MEMORANDUM

To: Bryan Healy, Village of Croton-on-Hudson Village Manager
CC: Dan O'Connor, Village Engineer; Linda Whitehead, Village Attorney
From: Nick Vamvas & Barbara B. Beall, PWS, LEED® AP
Date: December 17, 2021
Re: Hudson National Golf Club/Matrix Development, LLC – Solar Project - Engineering Review
Project #: 82050.00

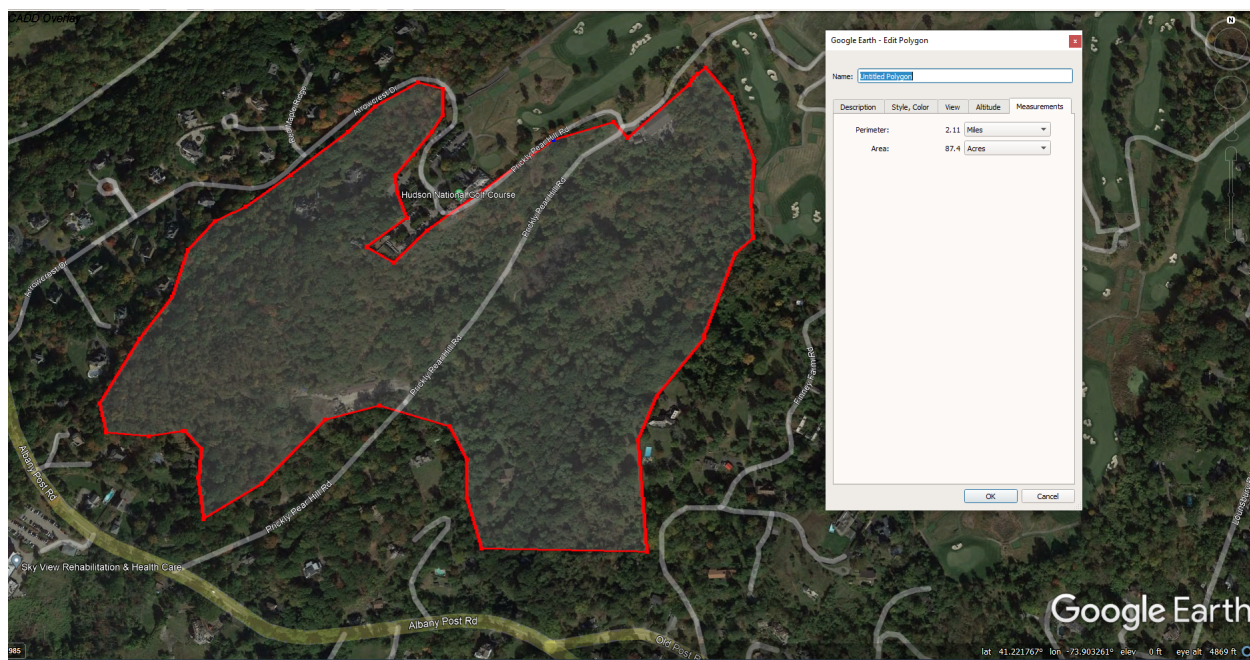
1. The TMA letter provided a figure titled "Regional Vegetation Associations on 2016 Aerial Photo" illustrating an area of "undisturbed" woodland (in dark green) that includes the 6.7 acres of solar array would be located. As shown in Figure 1 below, Chazen extrapolated the approximate limits of that "undisturbed" woodland into Google Earth as a polygon (excluding parking areas for the Hudson National Golf Club) and measured the polygon area. The red boundary is the approximate limit of the "undisturbed" woodland and is approximately 87 acres. See Figure 1 below.

2. Chazen notes that even this "undisturbed" woodland is bisected by Prickly Pear Hill Road. It is also encroached upon by the maintenance area in the vicinity of the proposed solar array, two large homes on the south side of Arrowcrest Drive and by what appears to be accessory parking for the clubhouse on the south side of the entrance drive.
3. Chazen then reviewed NYSDEC's Final Supplemental Environmental Impact Statement on the Oil, Gas and Solution Mining Regulatory Program, prepared in 2015¹, as this document had a significant d

- a. Based on measurements using Google Earth, the size of the "undisturbed" woodland where the solar array is being placed is approximately 87 acres, which is less than the 150 acres identified by the NYSDEC in the referenced DEIS as being adequate habitat for interior birds.
- b. The 87-acre "undisturbed" woodland is further bisected by Prickly Pear Hill Road and encroached upon by two large homes.
- c. The proposed solar array would be located adjacent to another open encroachment, the maintenance area for the golf course.
- d. The December 1, 2020 Biodiversity and Habitat Assessment prepared by TMA states "[i]t is noted that Japanese barberry (*Berberis thunbergii*) and Morrow honeysuckle (*Lonicera*
